## AMENDMENT OF SOLICITATION

1. AMENDMENT/MODIFICATION NO. <b>0002</b>	2. EFFECTIVE DATE <b>MAY 09, 2003</b>
3. ISSUED BY  DEPARTMENT OF THE ARMY, BALTIMORE DISTRICT CORPS OF ENGINEERS P.O. BOX 1715 BALTIMORE, MARYLAND 21203-1715

4. NAME AND ADDRESS OF CONTRACTOR (Name, street, county, State and ZIP Code)	4A. AMENDMENT OF SOLICITATION NO. <b>DACW31-03-R-0012</b> <hr/> 4B. DATED (SEE ITEM 5) <b>APRIL 15, 2003</b>

6. ACCOUNTING AND APPROPRIATION DATA (If required)  <b>NEVAL THOMAS ELEMENTARY SCHOOL, WASHINGTON, DC</b>	
7. DESCRIPTION OF AMENDMENT/MODIFICATION (Organized by UCF section headings, including solicitation/contract subject matter where feasible.)  <b>SEE THE FOLLOWING PAGES</b>	
Except as provided herein, all terms and conditions of the document referenced in Item 4A, as heretofore changed, remains unchanged and in full force.

Project No.: 2001016.00  
Designed by: EJ  
Drawn by: DC  
Checked by: SML  
Date: 04/21/2003  
Drawing No.: ADD-A-04

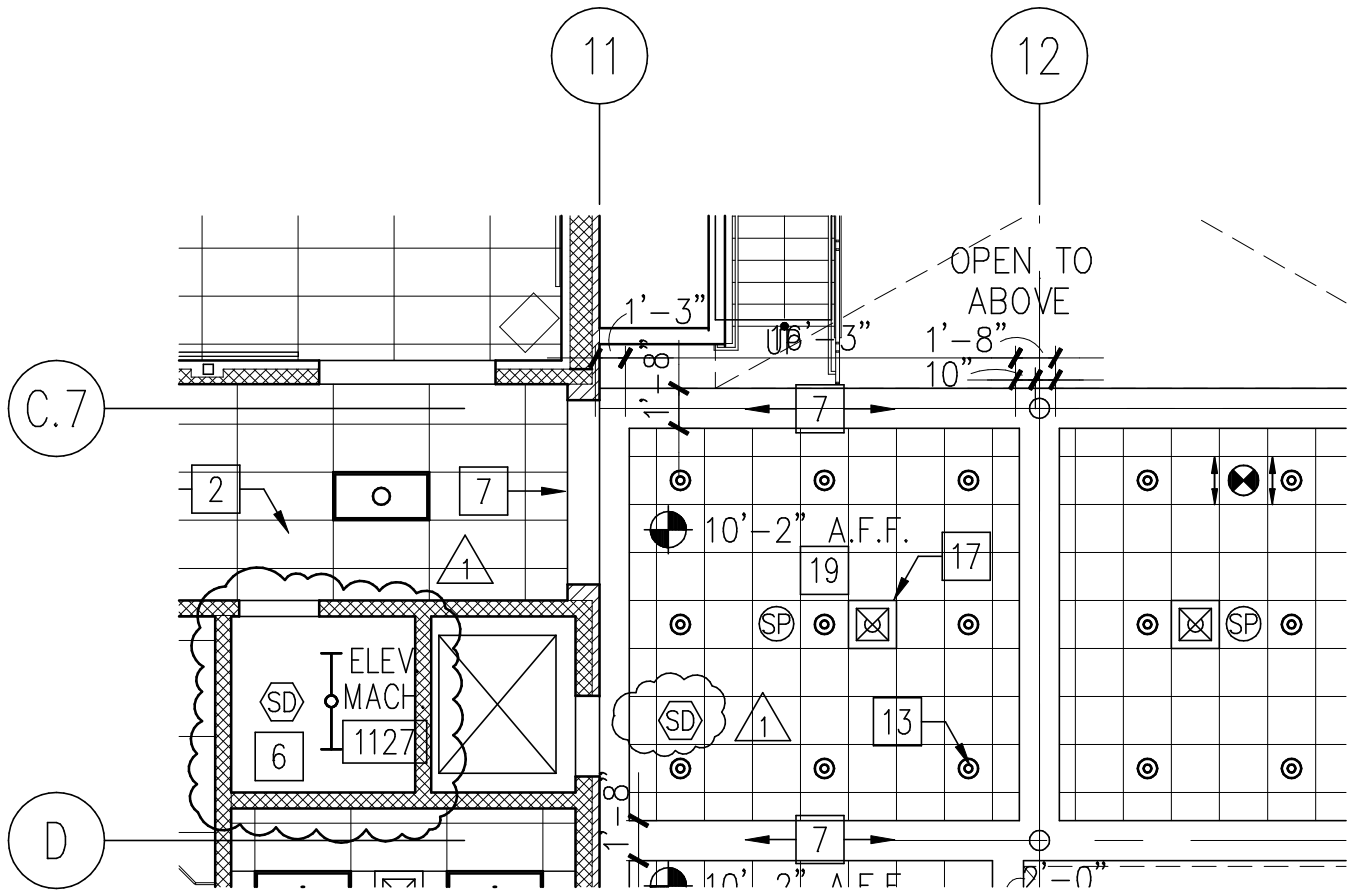
- 6) Sheet A105: Revise this plate that was reissued in Amendment No. 0001 in accordance with the attached Sketch ADD-A-04.
- 7) Sheet A504: Revise this plate that was reissued in Amendment No. 0001 in accordance with the attached Sketches ADD-A-01 and ADD-A-02.
- 8) Sheet A801: Revise this plate in accordance with the attached Sketch ADD-A-05.
- 9) Sheet A901: Revise this plate in accordance with the attached Sketches ADD-A-06 and ADD-A-07.

Project:	NEVAL THOMAS ELEM. SCHOOL	Project No.:	2001016.00
	650 ANACOSTIA AVE., NE	Designed by:	DT
	WASHINGTON, DC 20019	Drawn by:	EF
Title:	LEVEL ONE ELECTRICAL	Checked by:	TS
	POWER PLAN - PART A	Date:	04/21/2003
Modifies	Drawing No.: E201	Scale:	1/8"=1'-0"
		Drawing No.:	ADD-E-05

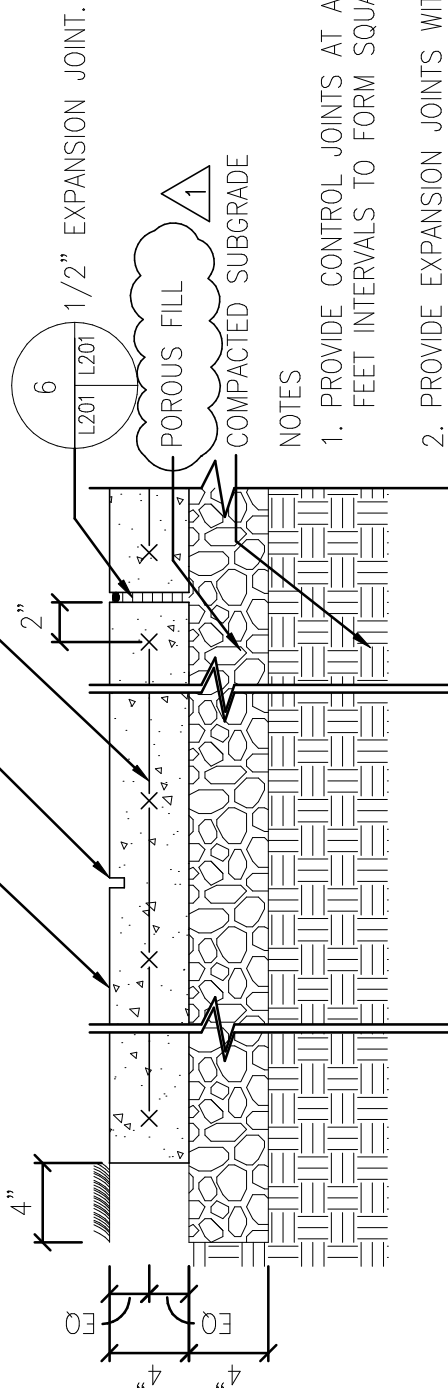
- 14) Sheet C403: Revise this plate in accordance with the attached Sketches ADD-C-02 and ADD-C-03
- 15) Sheet E201: Revise this plate that was reissued in Amendment No. 0001 in accordance with the attached Sketch ADD-E-05.

Project: NEVAL THOMAS ELEM. SCHOOL Project No.: 2001016.00  
650 ANACOSTIA AVE., NE Designed by: TTE  
WASHINGTON, DC 20019 Drawn by: AL  
Title: DRILLED PIER WITH BELL DETAIL Checked by: TTE  
Date: 04/21/2003  
Modifies Drawing No.: S3.0 Scale: N.T.S. Drawing No.: ADD-S-07

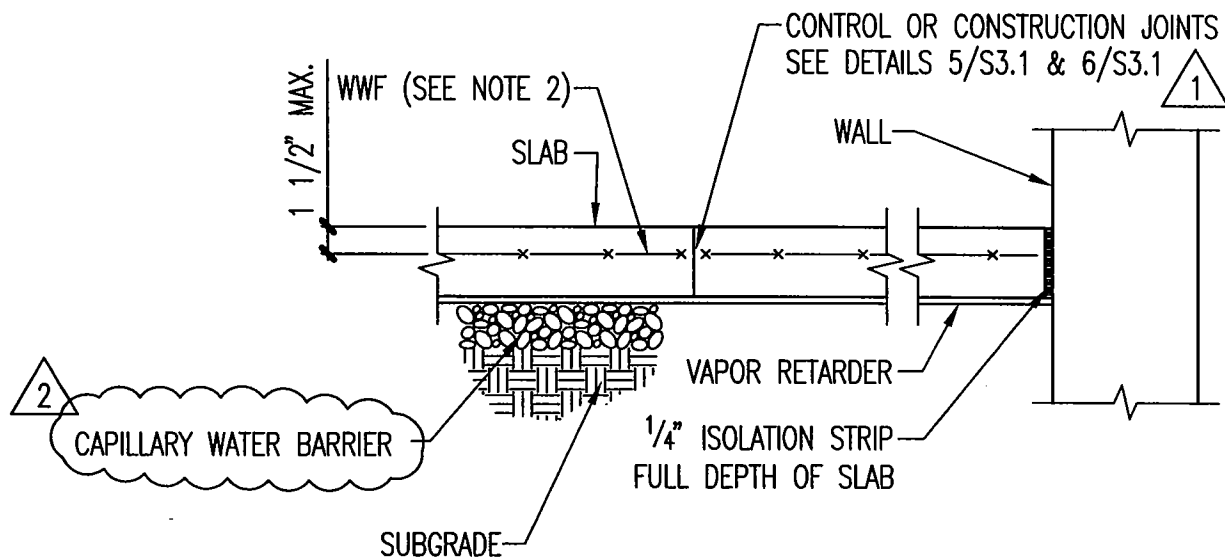
- 19) Sheet S3.0: Revise this plate that in accordance with the attached Sketch ADD-S-07.
- 20) Sheet S3.1: Revise this plate in accordance with the attached Sketches ADD-S-08, ADD-S-09 and ADD-S-10.

# **1 DRILLED PIER WITH BELL (CAISSON)**
